CHIQUITA CANYON SANITARY LANDFILL

COMPLIANCE ORDER PERTAINING TO 27

DATE: May 1, 2025

Figure 8. Fissure and Crack Monitoring Report for February 2025. (Source: Geo-Logic Associates)

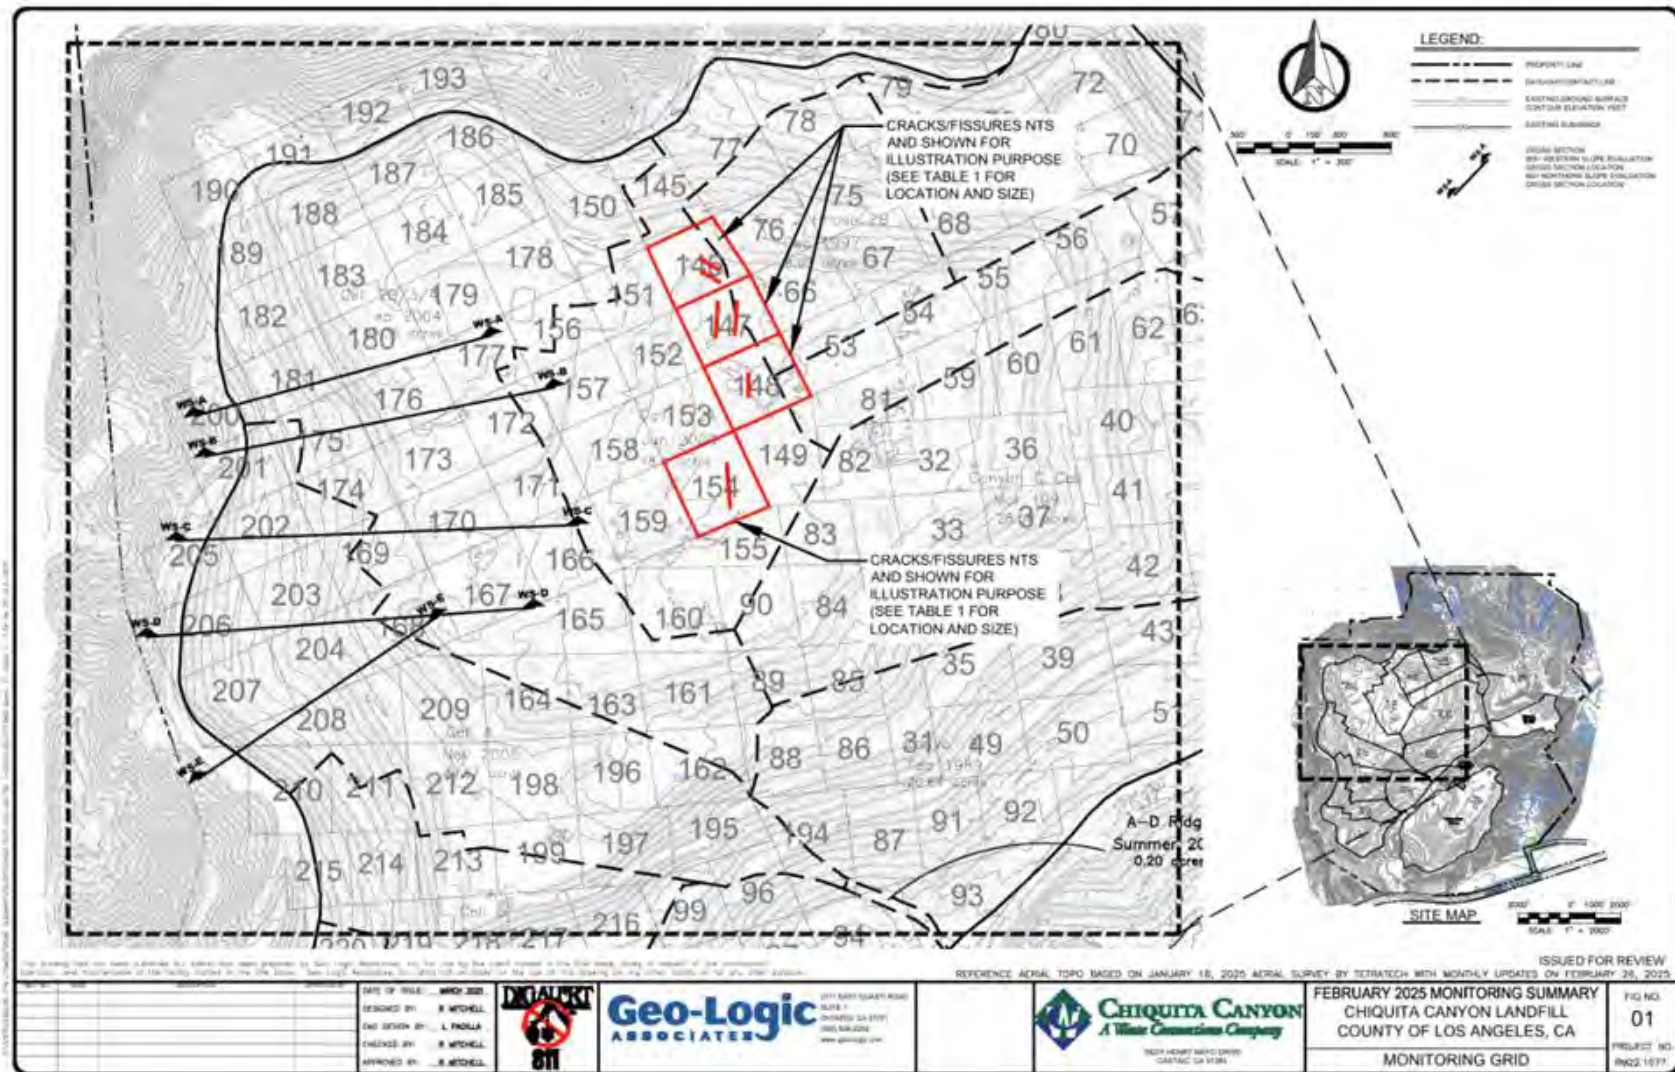
The CCL Settlement and Fissure Reports also align with the TMP temperature spikes data in grids. CCL's consultant, Geo-Logic Associates, provided a summary map of the recently occurring fissures in February 2025 (see **Figure 8**). Significant fissures and areas where the soil collapsed were documented in Grids 146, 147, 148, and 154. CalRecycle also reviewed FLIR data from October 2024; however, CCL has refused to provide the temperature layer on each photo. All data should be available.

New TMPs for Chiquita Canyon Landfill, March 2025

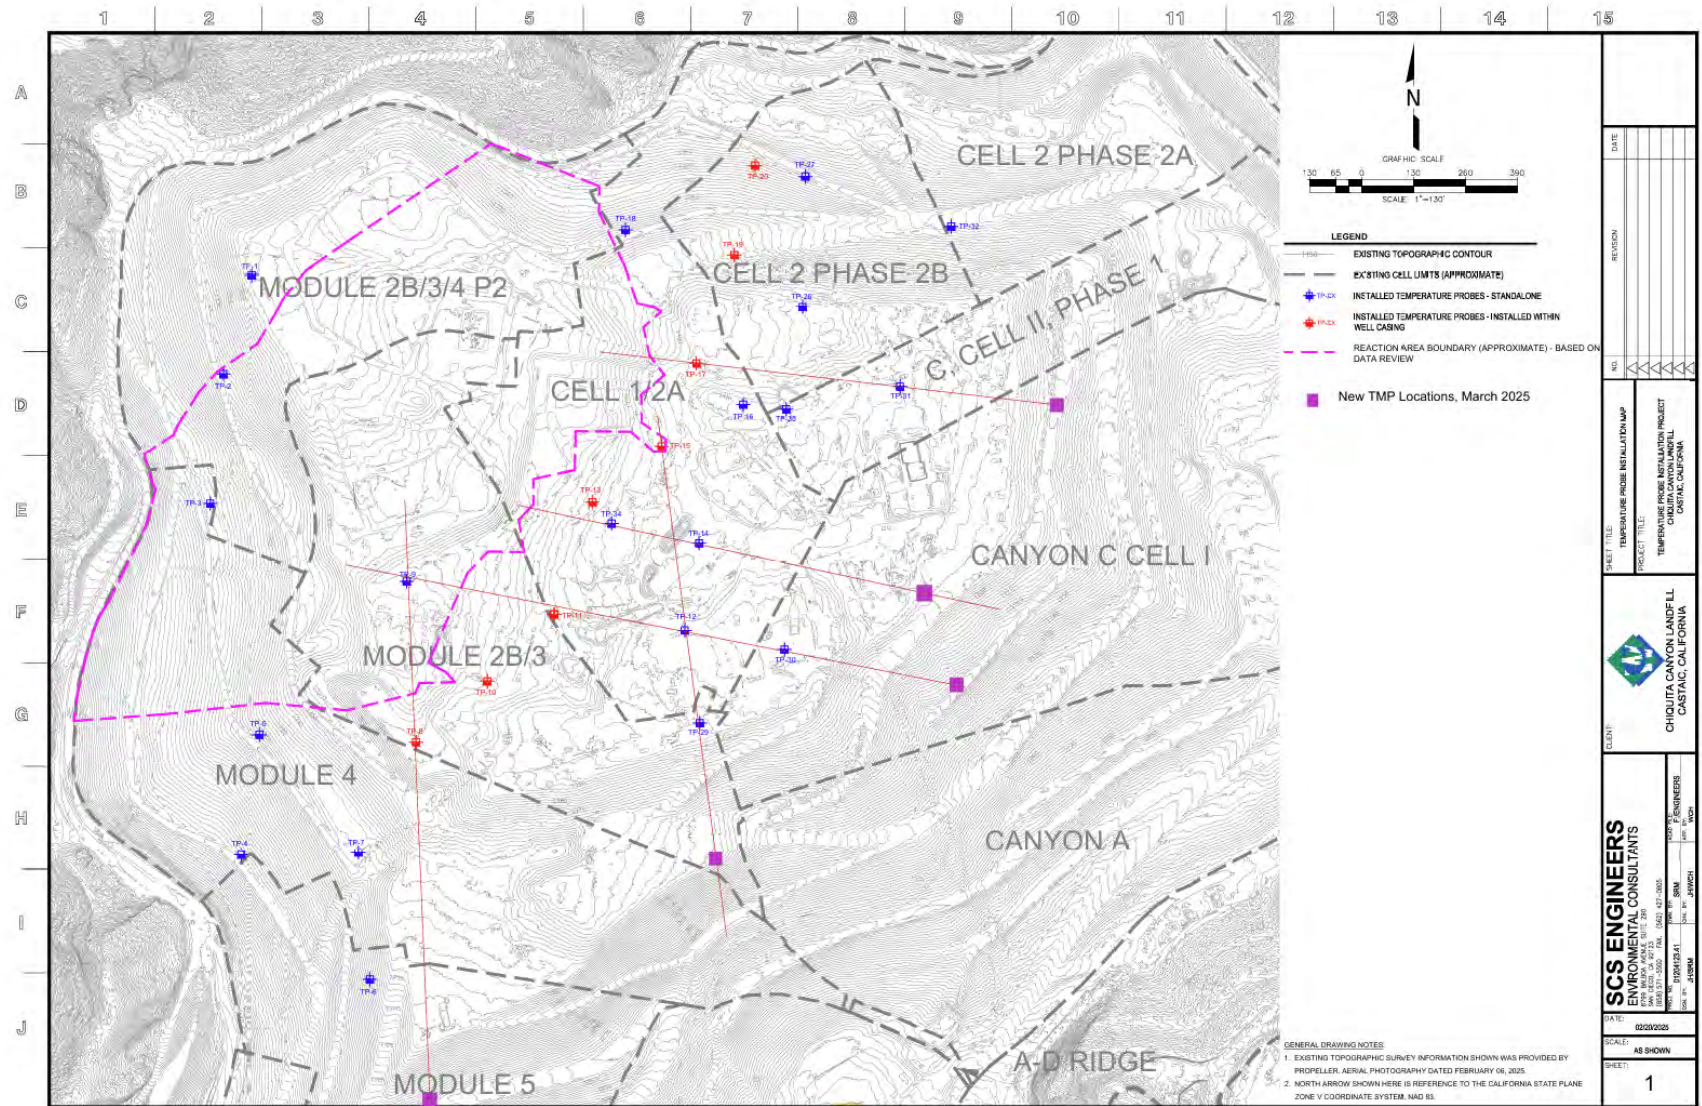
4.4 Install Additional TMPs: Five new TMPs must be installed at locations specified in Attachment A of the March 28, 2025 CalRecycle Letter. TMPs must be installed at the following depths: 15 feet, 30 feet, 45 feet, and 75 feet. Beyond 75 feet, additional TMP depths must be determined using the equation $[(\text{Max Boring Depth} - 75 \text{ feet})/4]$ rounded up to the nearest tenth or fifth as described in the March 19, 2025 LEA Letter. Provide a final completion report that includes a map by **August 4, 2025**.

Figure 1. Temperature profiles over six weeks from 1/9/2025 to 2/19/2025 from SCS report dated February 20, 2025.

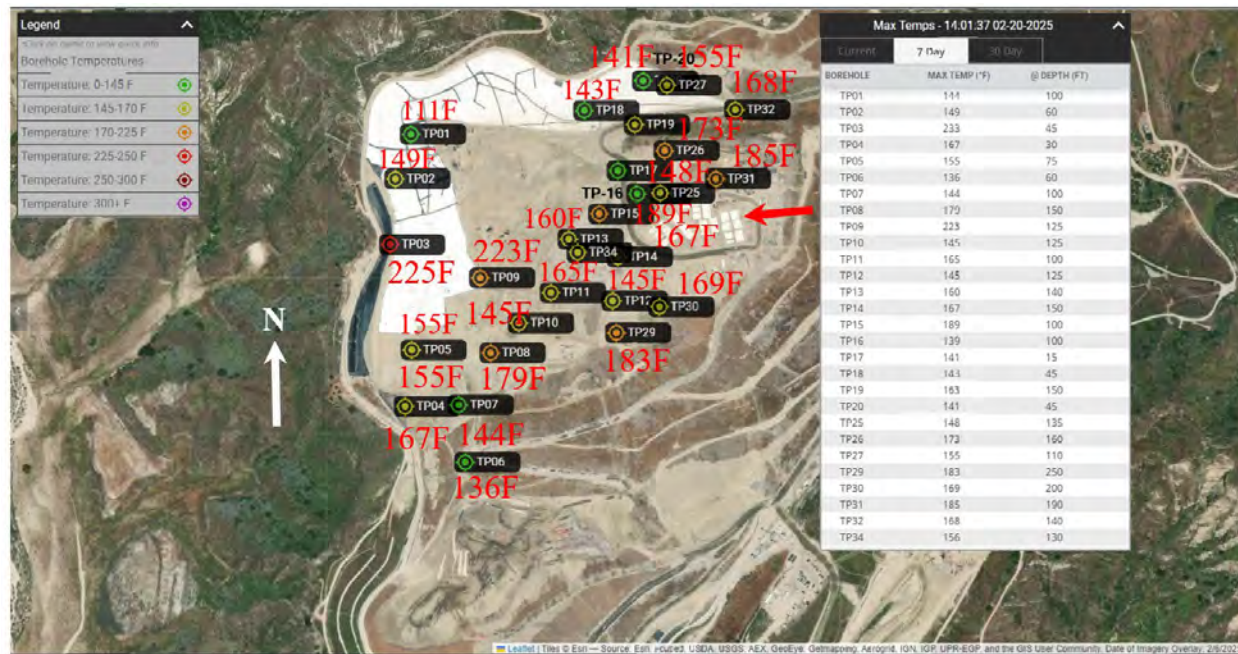
SCS presents Waste Borehole Maximum Temperature Profiles Over 6 Weeks from January 9, 2025 to February 19, 2025.⁶ An aerial image of CCL with a table of maximum temperatures is included in the subject SCS Report and reproduced in **Figure 1**. I have placed the maximum waste temperature from the table in **Figure 1** adjacent to some of the gas extraction wells to facilitate understanding the extent of the SET Event, especially on the east side of CCL. **Figure 1** shows waste temperatures of 183°F and 185°F at the eastern side of the top deck of the CCL. This means the SET Event has migrated from the western slope (TP03) to the eastern side of the CCL (TP31). Expansion of the SET Event has the following implications:

- Elevated temperatures (185°F to 189°F) surround the leachate tank farm (see red arrow in **Figure 1**). This area is going to undergo significant settlement, if it has not already started to do so, due to thermal breakdown of the buried waste. This settlement will cause differential movement of the leachate tanks, which could result in a leachate release. As a result, I recommend the leachate tank farm be moved off the top deck and to a site off the CCL and on native soil because the SET Event continues to expand.

Figure 2. Extent of elevated temperatures from March 27, 2024 to February 26, 2025.

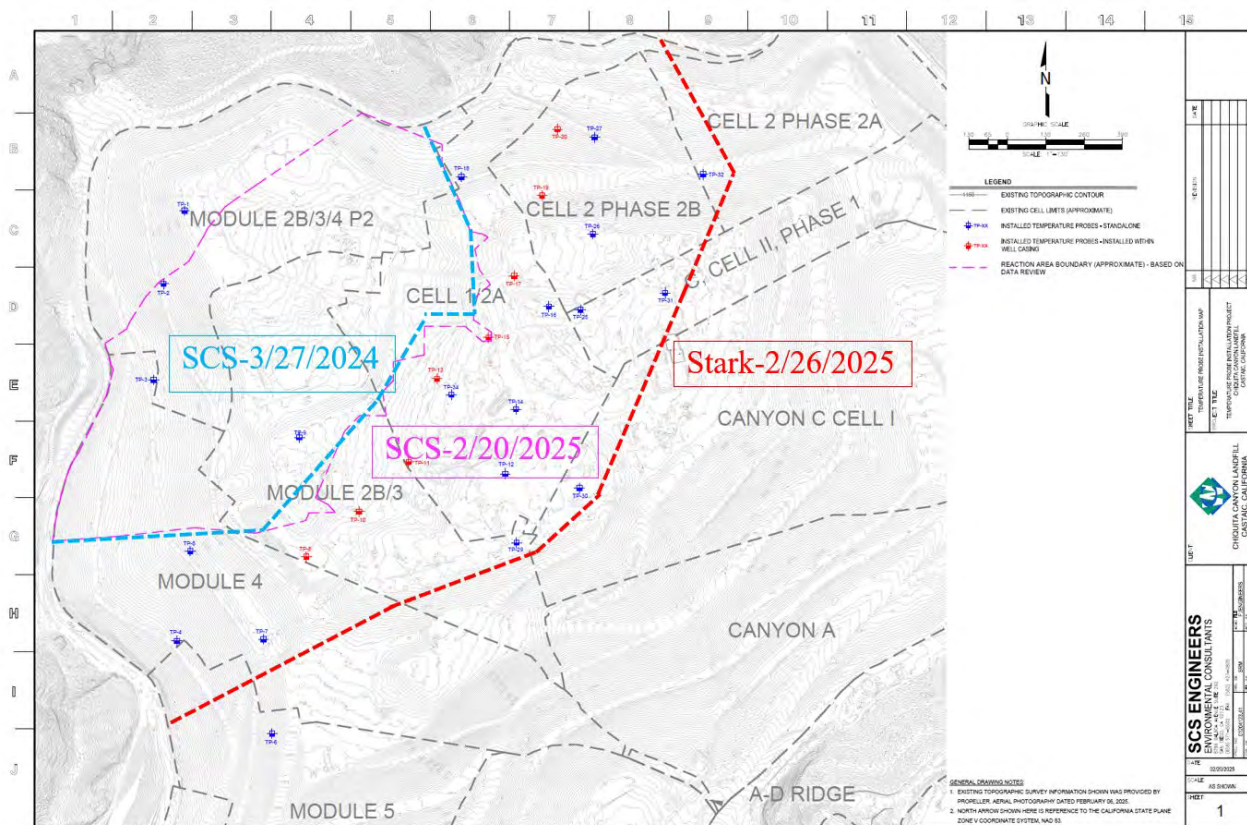
Figure 2 presents Sheet #1 from the SCS Report that presents the Waste Borehole Maximum Temperature Profiles Over 6 Weeks from January 9, 2025 to February 19, 2025.⁷ The dashed pink line represents the extent of the SET Event as determined by SCS on February 20, 2025. This extent is slightly larger than the dashed blue line, which represents the extent of the SET Event on March 27, 2024 as reported by SCS in the initial Soil Reaction Break/Barrier Plan.⁸ **Figure 2** also presents my extent of the SET Event as of February 26, 2025 (see dashed red line) based on the Waste Borehole Maximum Temperature Profiles Over 6 Weeks from January 9, 2025 to February 19, 2025.⁹ **Figure 2** shows the western slope and entire top deck of the CCL is now part of the

SET Event, which is a significant increase over the extent reported by SCS on March 27, 2024¹⁰ and February 20, 2025.¹¹ Based on **Figure 2**, SCS believes the SET Event only covers about 28 acres as of February 20, 2025 whereas my extent of the SET Event covers about 90 acres.

Figure 7. Extent of elevated temperatures on February 26, 2025 and location of a possible vertical barrier to isolate southernmost 13 acres.

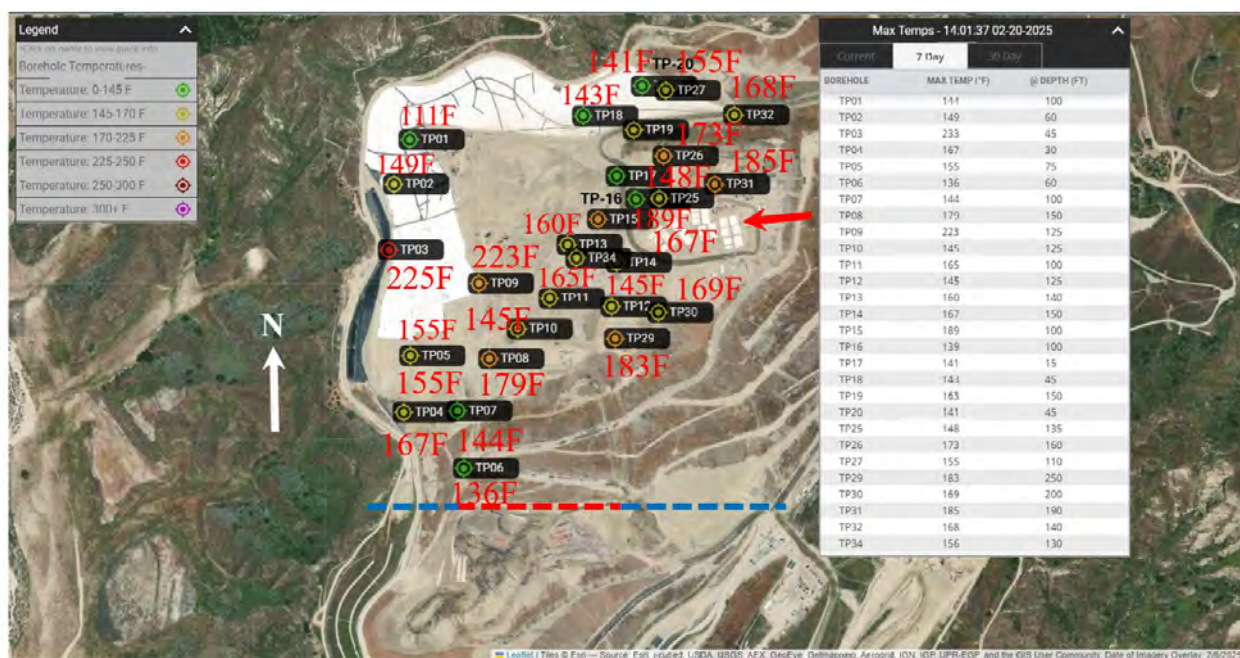
This section discusses installing a thermal barrier south of TP06 (see dashed red and blue line in **Figure 7**). A thermal barrier is recommended along the dashed red and blue line in **Figure 7** for at least the following reasons:

- CCL is using the approximately 13 acres south of the dashed red and blue line in **Figure 7** for disposal operations so elevated temperatures should be prevented from reaching this area, so the landfill continues to have an area to dispose of on-site wastes.
- Ensure continued ingress and egress from the CCL.
- Reduce the amount of waste that can be consumed by the SET Event and thus reduce the duration of odors and emissions to the surrounding communities.
- Maintain stability of the southern sideslope.

The red dashed line in **Figure 7** roughly delineates the location of a thermal barrier already constructed by CCL. The extent and depth of the thermal barrier are not known, so I request this information be provided by CCL. The blue dashed lines in **Figure 7** indicate the existing thermal barrier should be extended east and west so the SET Event cannot go around or under the existing thermal barrier.

If the existing thermal barrier does not extend to near below the leachate level, vertical elements can be used to create a vertical thermal barrier to prevent the SET Event from impacting the southernmost 13 acres of the CCL. The vertical elements involve excavating a vertical shaft using a three or four-foot bucket auger drill rig, which is being used to install gas extraction wells at CCL. These vertical elements would be constructed along the dashed red and blue lines in **Figure 7**. After excavating the shaft, it could be backfilled with a soil-bentonite or soil-cement mix. The shafts would be tangent, i.e., touching, or overlapped (see **Figure 7**) to create a continuous barrier across the toe of the southern sideslope to prevent the SET Event from consuming the southernmost 13 acres. If heat transfer calculations require a wider thermal barrier, a second row of vertical elements could be constructed north or south of the initial row (see **Figure 7**). The secondary row would be tangent to the initial row and be centered at each intersection of the initial row as shown below (see **Figure 7**).

5. Submit a Request For Information (RFI) regarding the current extent and depth of the thermal barrier installed near the southern end of the CCL (see red dashed line in **Figure 7**), and
